HISTORIC PRESERVATION COMMISSION

March 15, 2007

SUBJECT: Historic Area Work Permit #445713, tree removal

Address: 4 Oxford St, Chevy Chase (Chevy Chase Village Historic District)

Attached: Landscape Plan, 4 Oxford Street

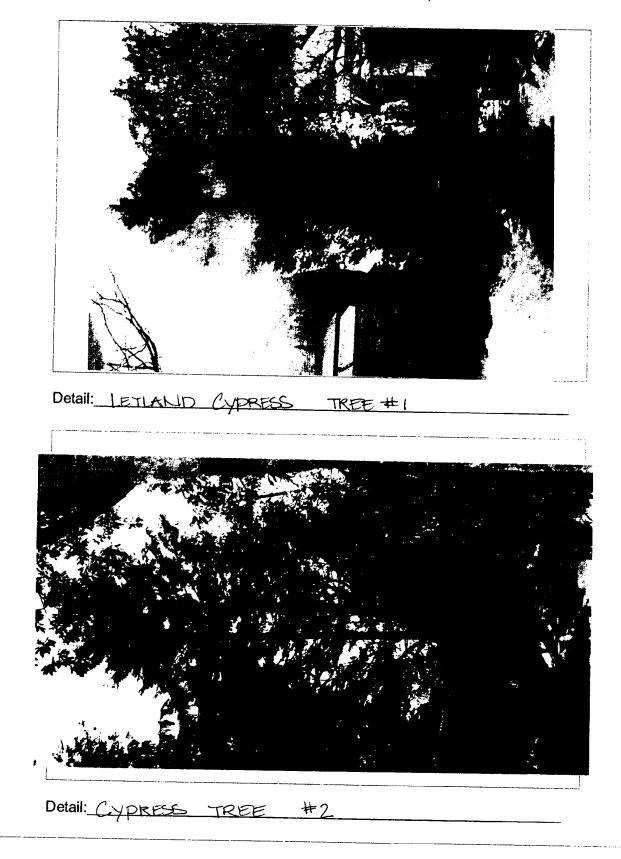
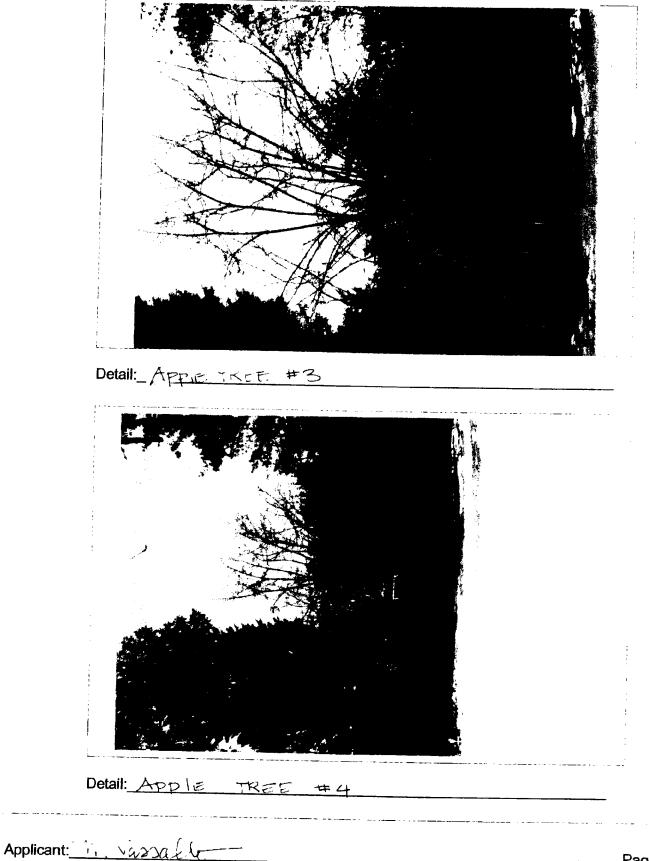
As the Commission has a 1/1 replacement policy for healthy trees they approve for removal, staff is recommending support of the Village Managers' approval with the added conditions that the deciduous trees to be replanted are a minimum of 3" caliper in size and an additional four (4) trees are to be planted on the subject property (two, 8' high evergreen, two, min 3" caliper deciduous).

Staff does concur with the applicant's testimony regarding the density of the canopy on the subject property, and as such, we would support the applicant electing to contribute the tree replacement costs for the four (4) trees for use in the Village of Chevy Chase's tree replanting program instead of installing the trees on their property.

For every tree to be removed, one tree from Montgomery County's native species list (min. 3" caliper deciduous or 8' high evergreen) will be planted on the property.

The owner may elect to contribute the equivalent cost of tree replacement for two, 8' high evergreen and two 3" caliper deciduous trees, from the Montgomery County Native Species list for use in the Chevy Chase Village tree planting program, instead of replanting four (4) of the approved trees to be removed.
